File		
AQUARIA SYSTEM PLUMBING DIAGRAM		
Size	Document Number	Rev
D	<Doc>	B
Date:	Tuesday, March 14, 2006	Sheet 1 of 1

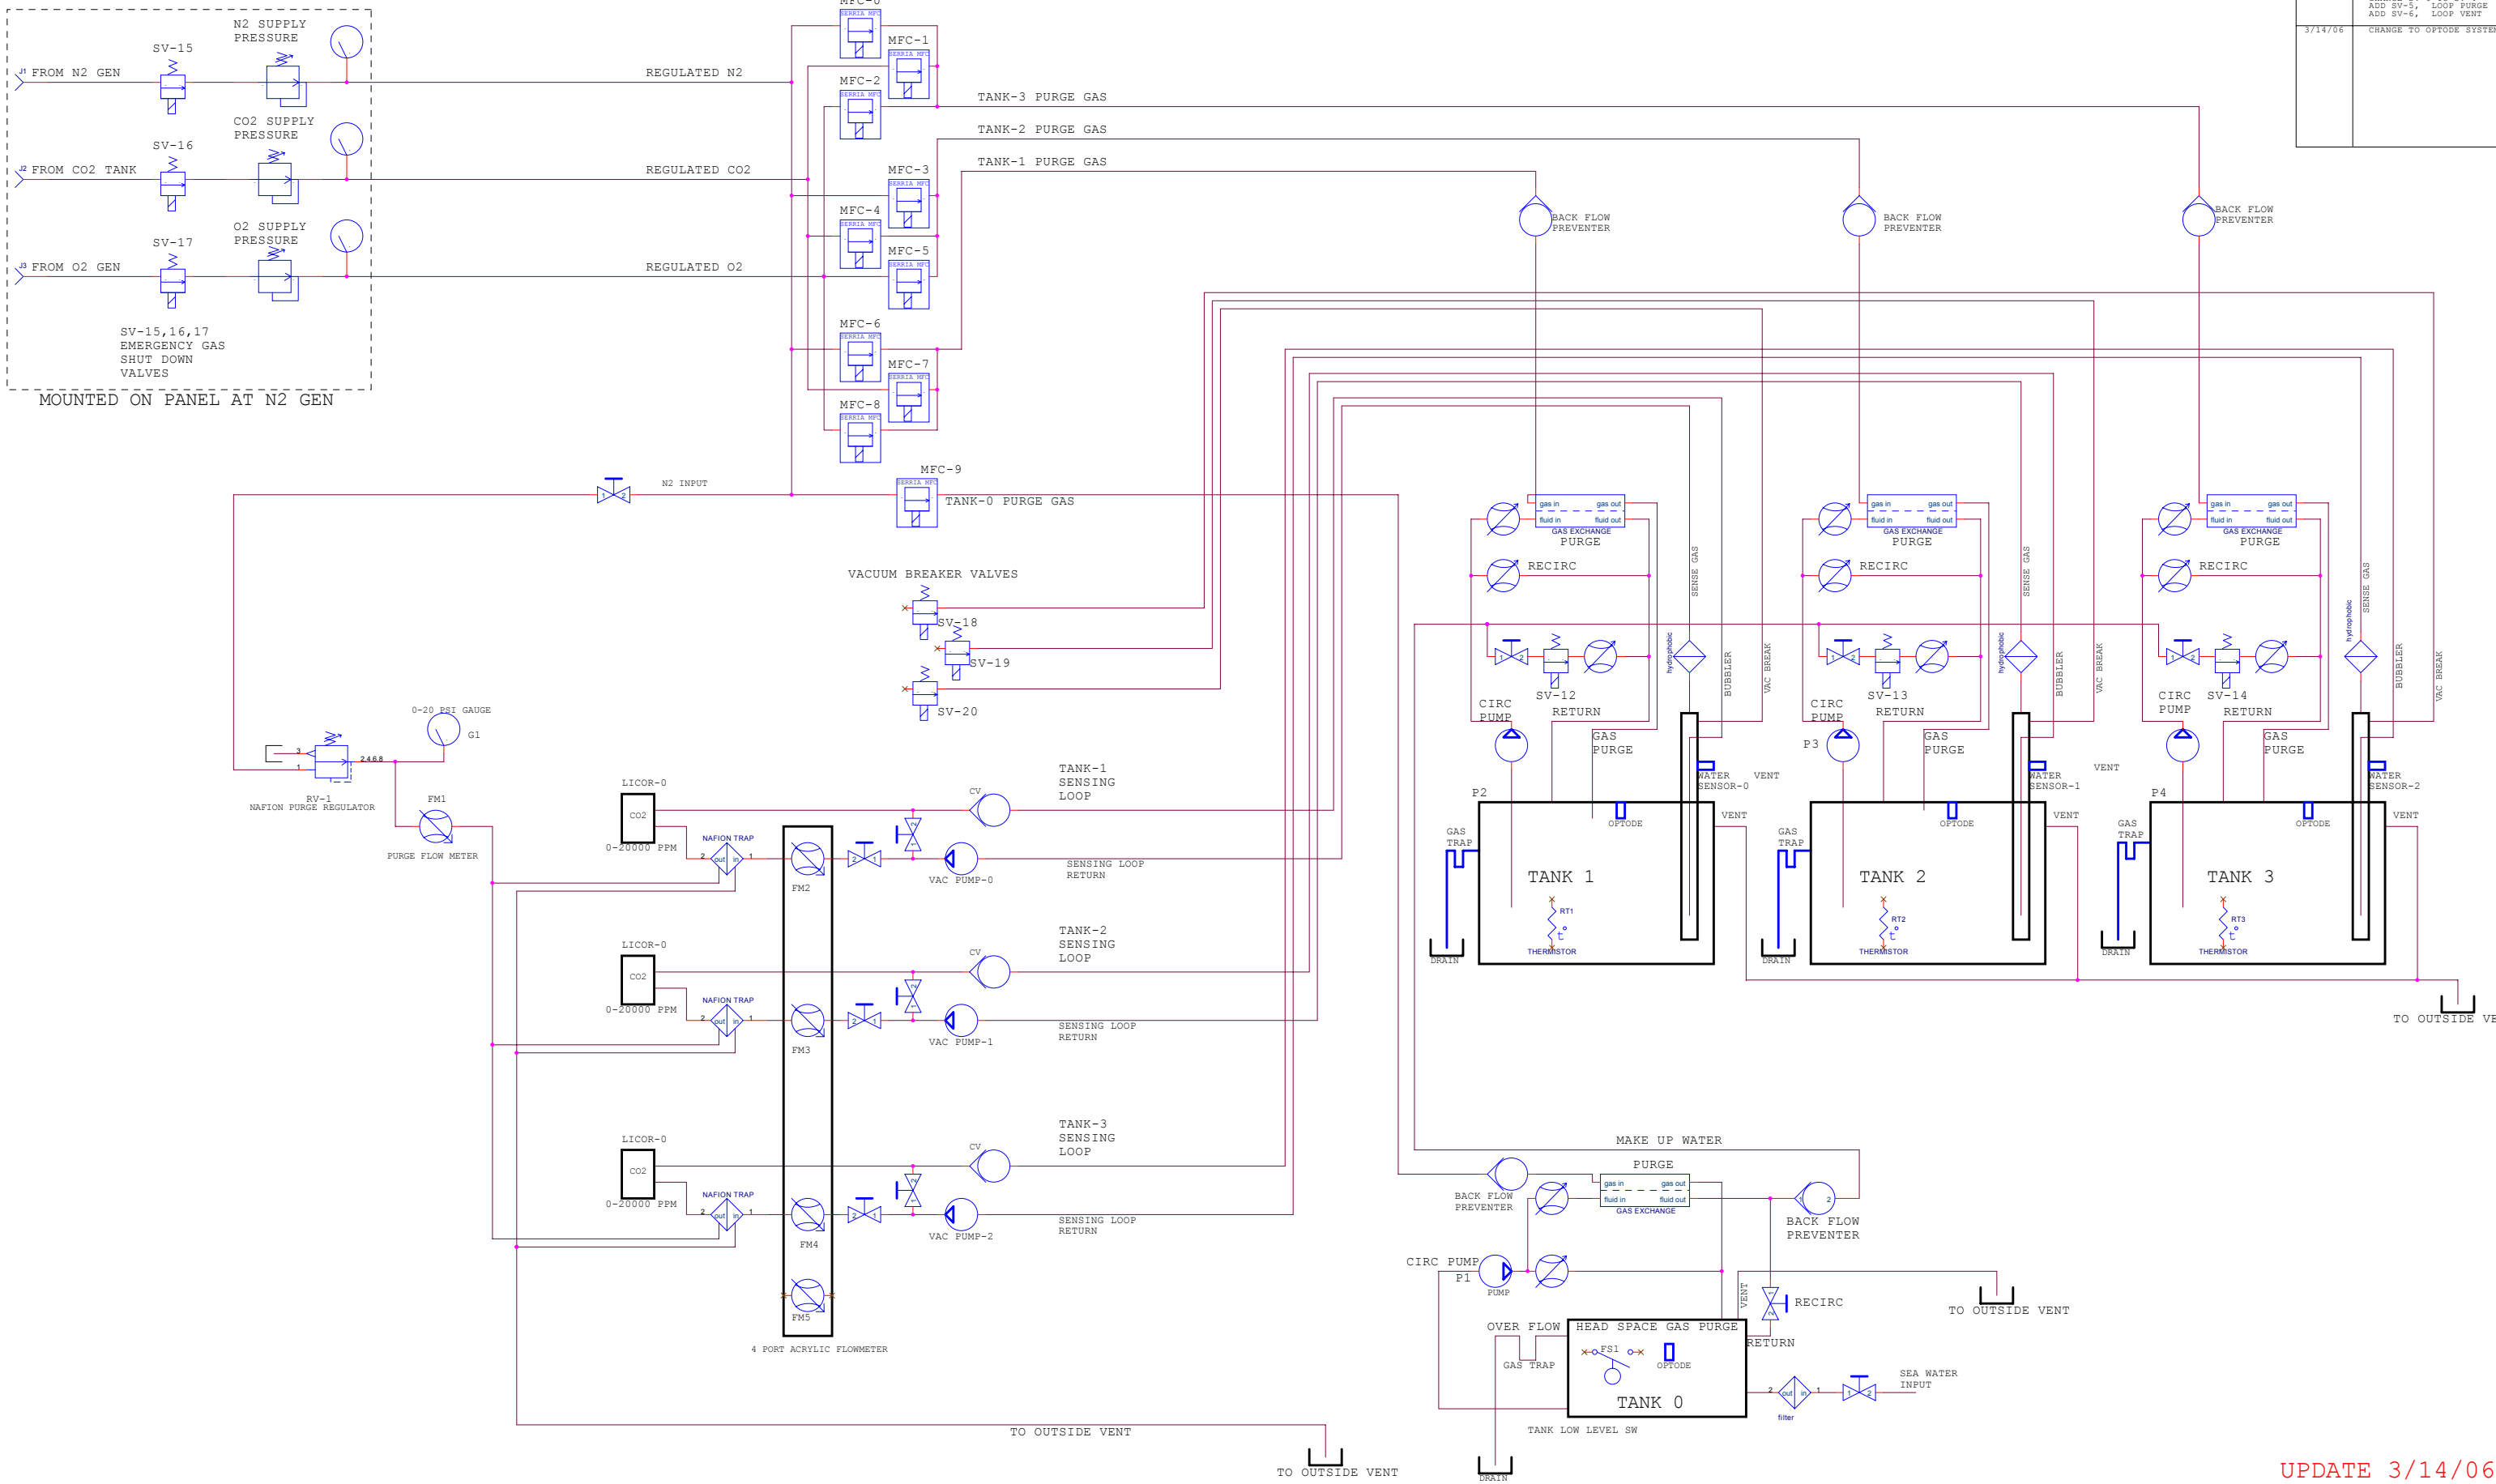
7/15/05	ADD WATER SENSOR ADD SV-18 CHANGE SV-0 TO SV-4 ADD SV-5, LOOP PURGE ADD SV-6, LOOP VENT
3/14/06	CHANGE TO OPTODE SYSTEM
